SRR-CWDA-2019-00028, Revision 0

GENERAL SEPARATIONS AREA GROUNDWATER FLOW MODELING

**Discussion Supporting NRC Onsite
Observation Visit
March 18-19, 2019**

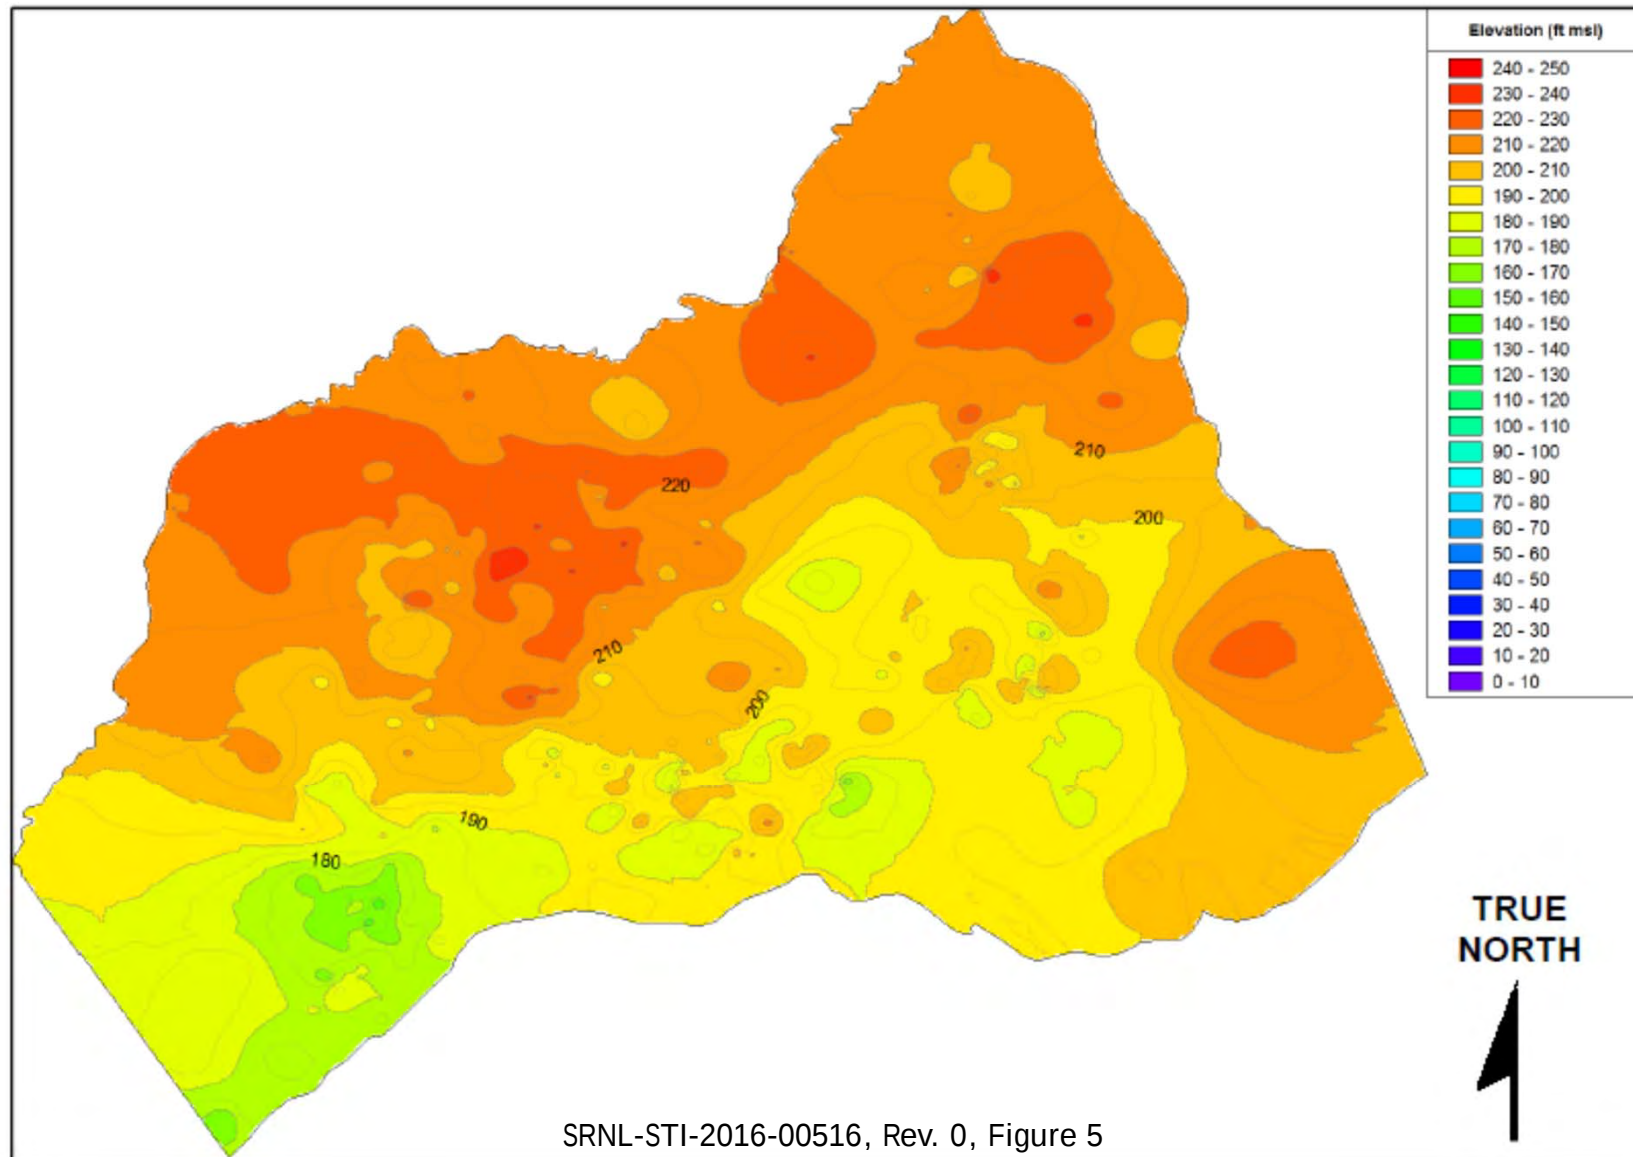
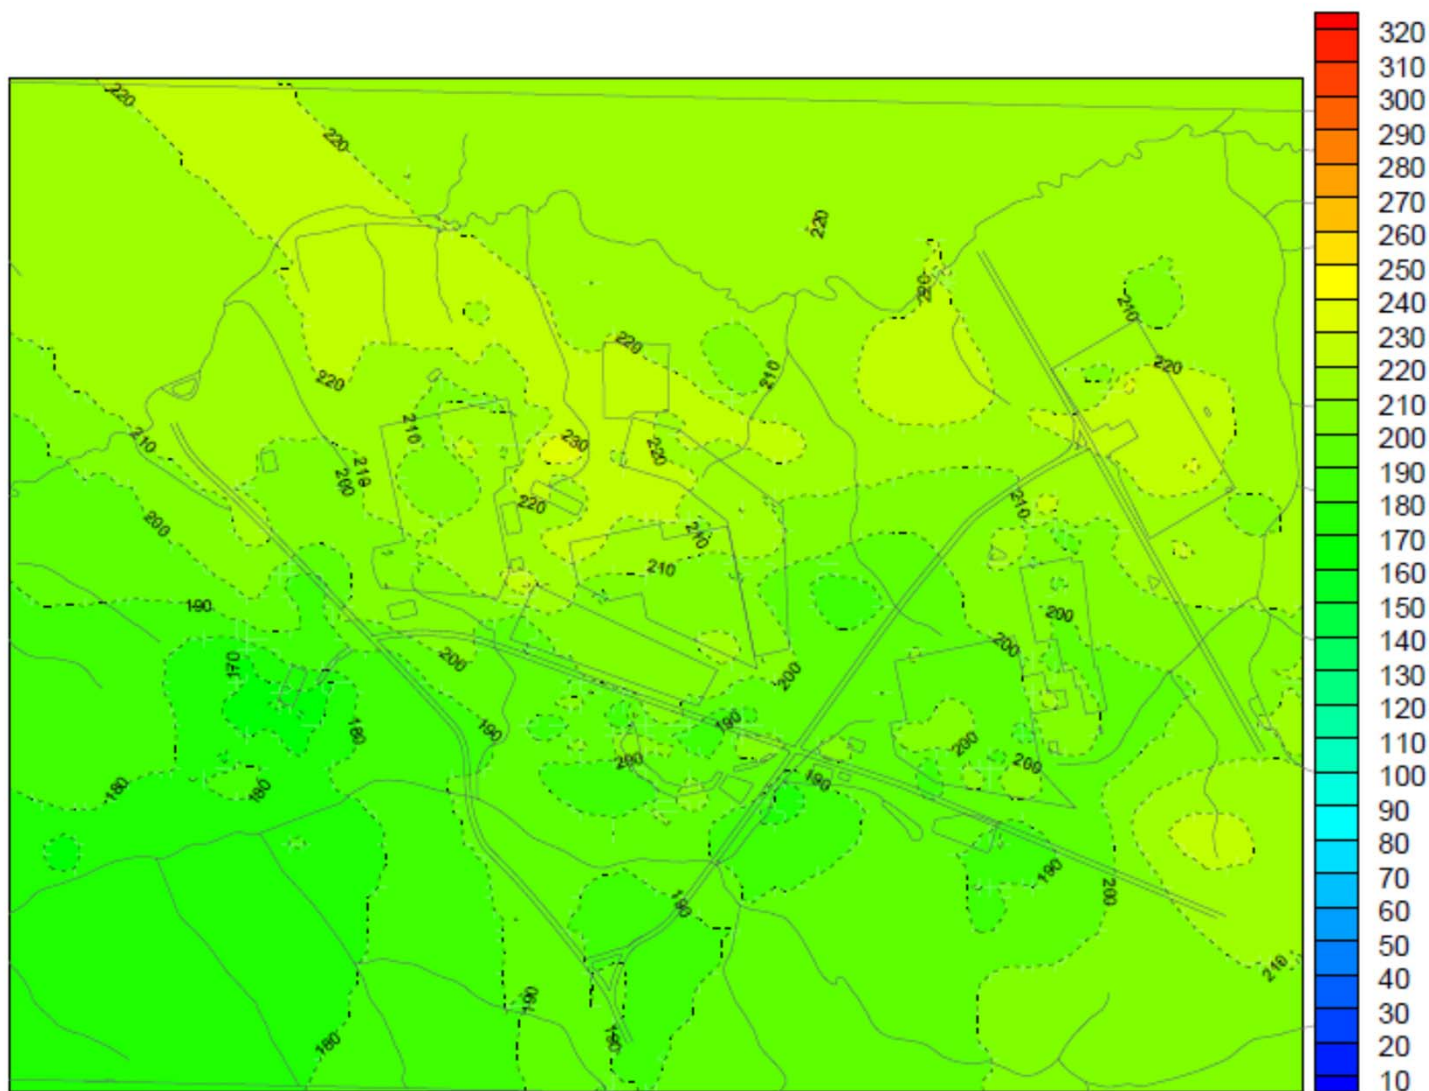
6. Discussion and comparison of SRNL-STI-2016-00516, Figures 5 - 9
with WSRC-TR-96-0399, Figures 3 - 7.
[\[Slides 14-15; comparison to GSA_2016/2018\]](#)

Figure 3
[SDF GSA_2004 Tracer Plume Simulation
of Steady-State Sources (Ci/L)]

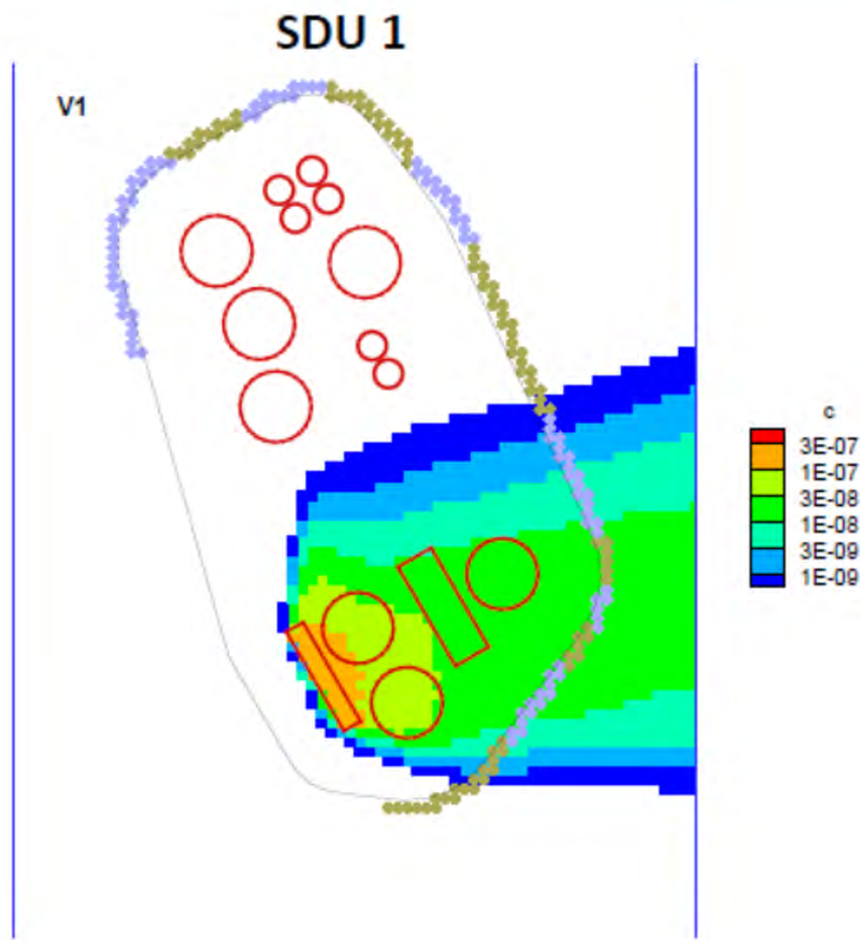
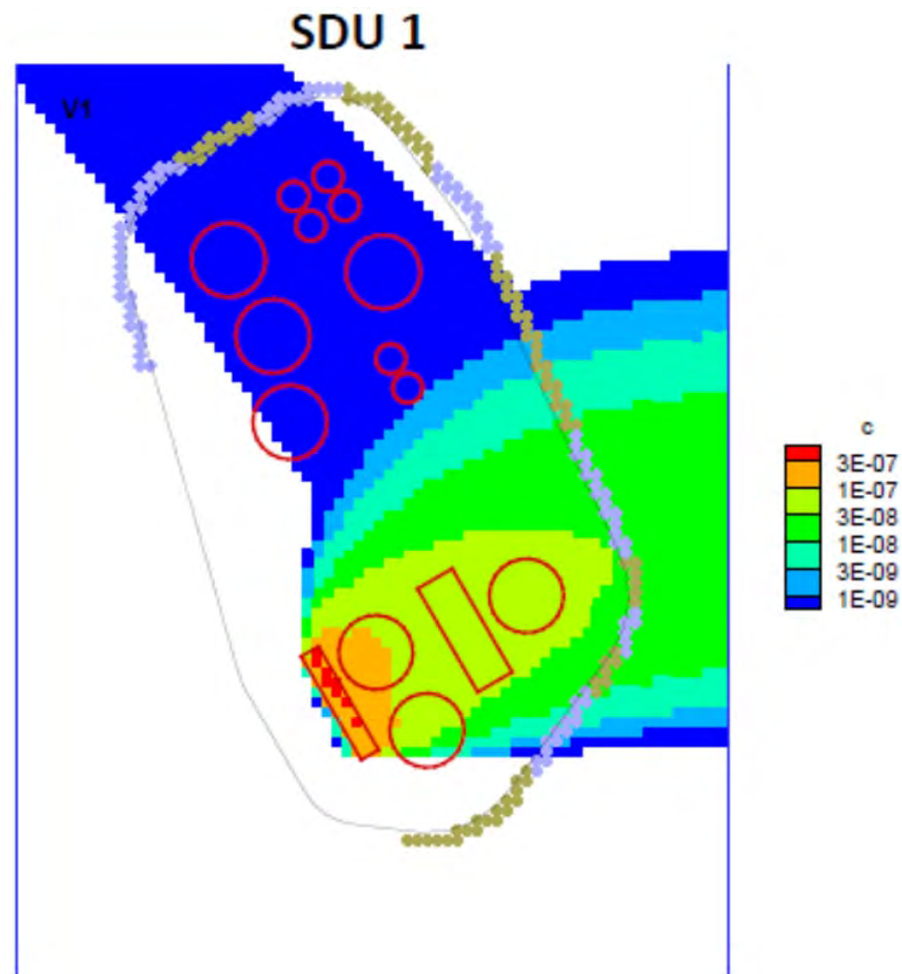
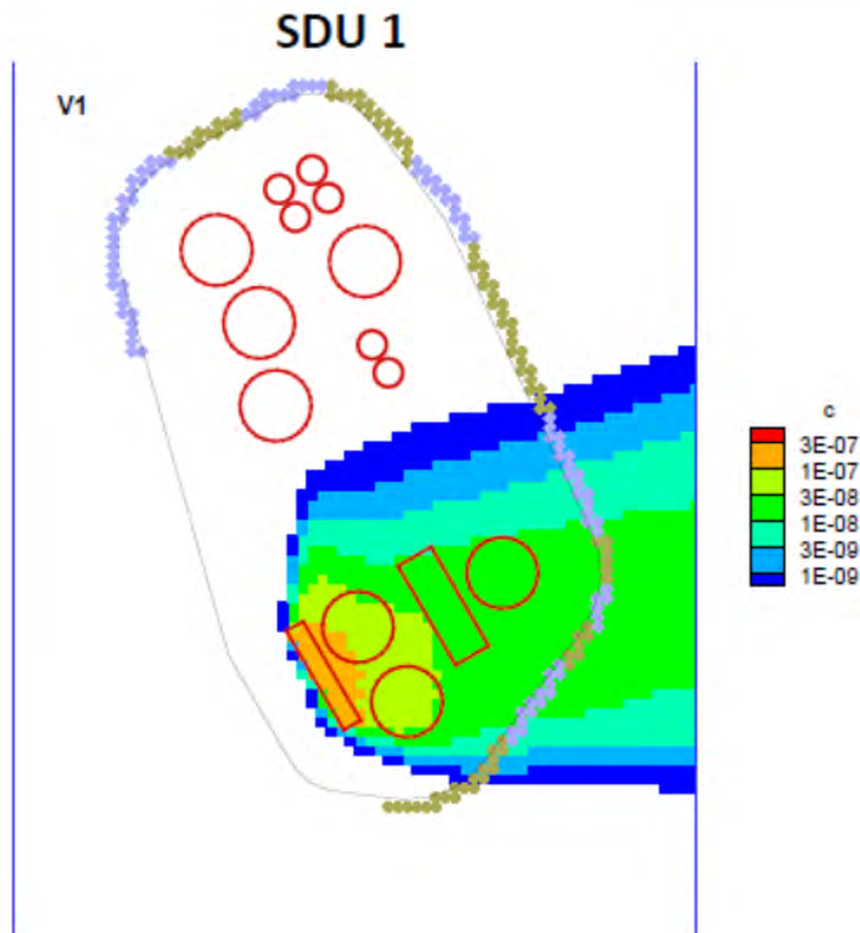
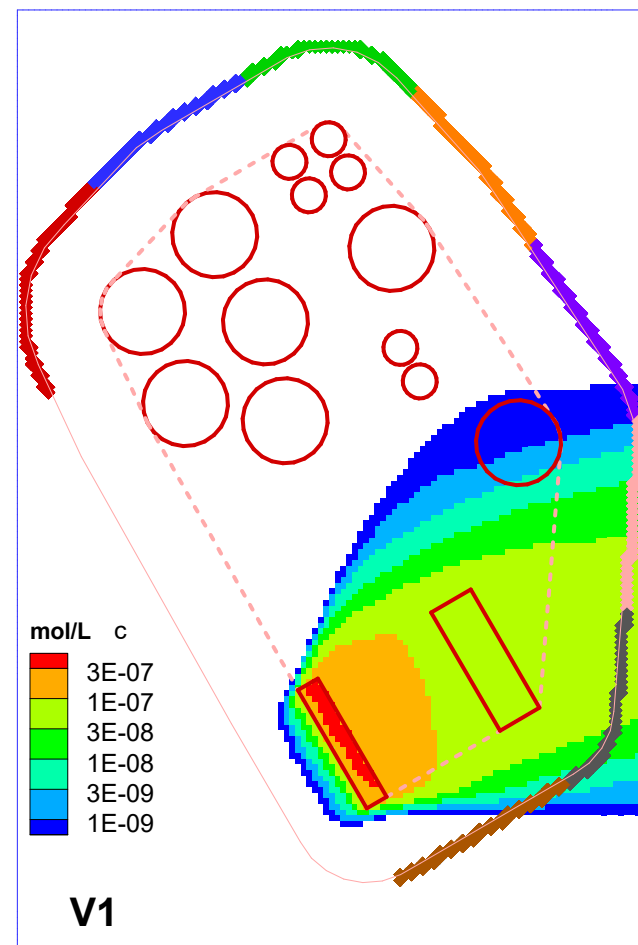
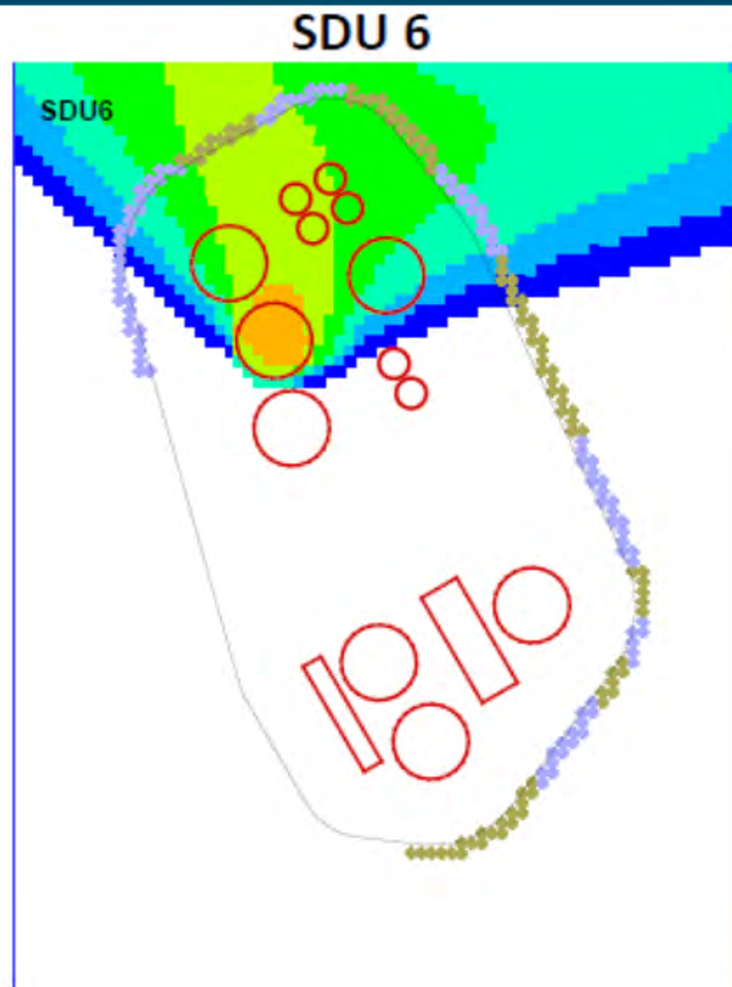
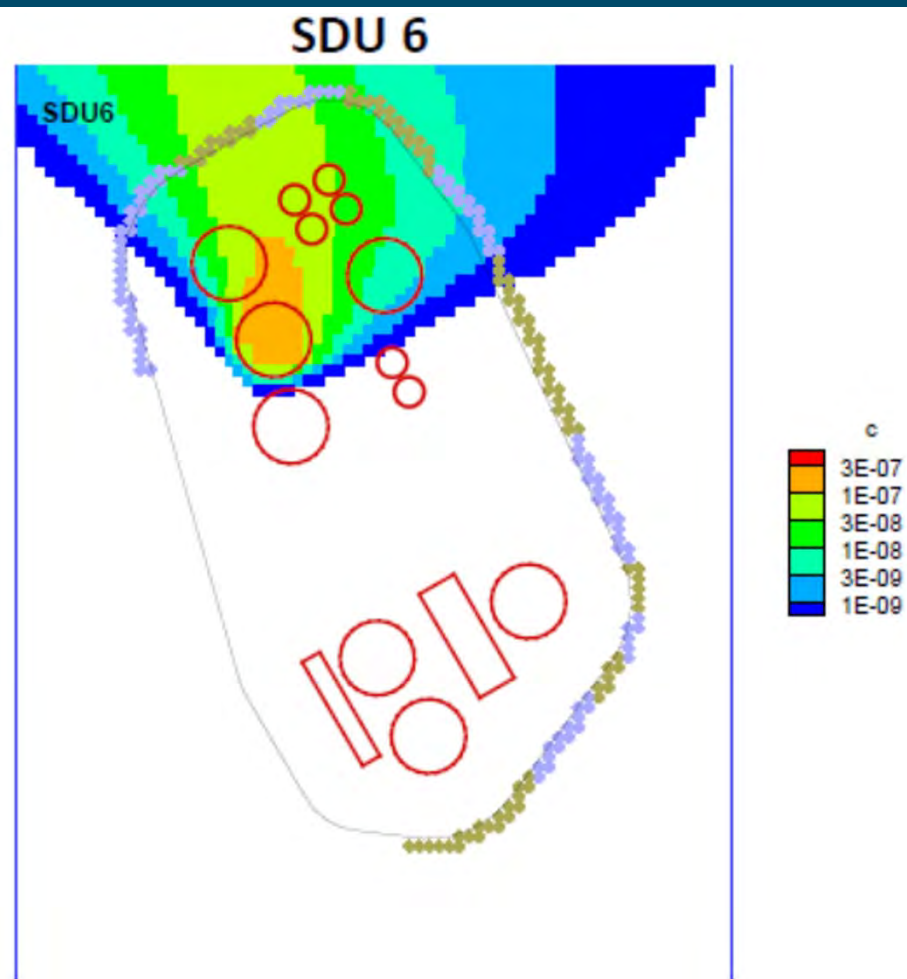
7. Discussion and comparison of Fig. 3 with Fig. 4.
[Slides 17-20; updated to GSA_2018]
8. Discussion plumes in Figures 4 and 5 (**5 and 6?**) and flow and transport influence of TCCZ.
[Slides 21-23; updated to GSA_2018]
9. Discussion on Fig. 8.
[Slides 24-25; updated to GSA_2018]
10. Where is the seepline located for Figure 10?
[Slide 26; updated to GSA_2018]
